**BID #14-25 Foundry Place Parking Office Construction**

**ADDENDUM 4**

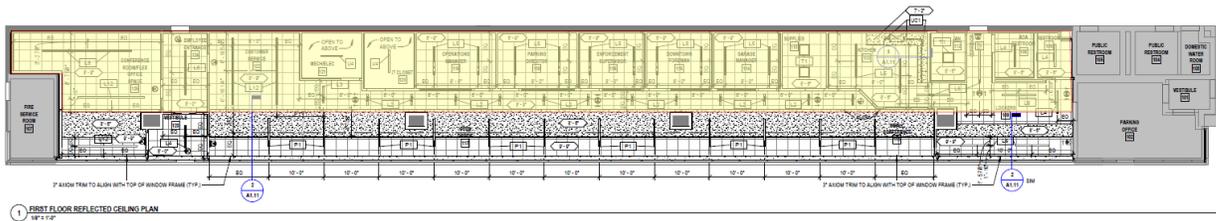
12. Specs read "Price as alternate to provide ACT ceilings beneath concrete deck/drive aisle (plan north of column line A) Do not provide beneath metal decking (plan south of column line A)". These column lines are not on the RCP'.

**What plan will show this alternate clearly?**

A. See highlighted area below that this refers to. This is to provide acoustical insulation on top of the ACT grid where it is beneath the driving surface above.

No. Include the additional insulation above the ACT as part of the basic work scope in this area, not as an alternative. Make the following change in the SPECIFICATIONS

**Delete** paragraph C. "Provide add alternate pricing for supplementary insulation above ceiling where indicated. Do not include cost in base bid."
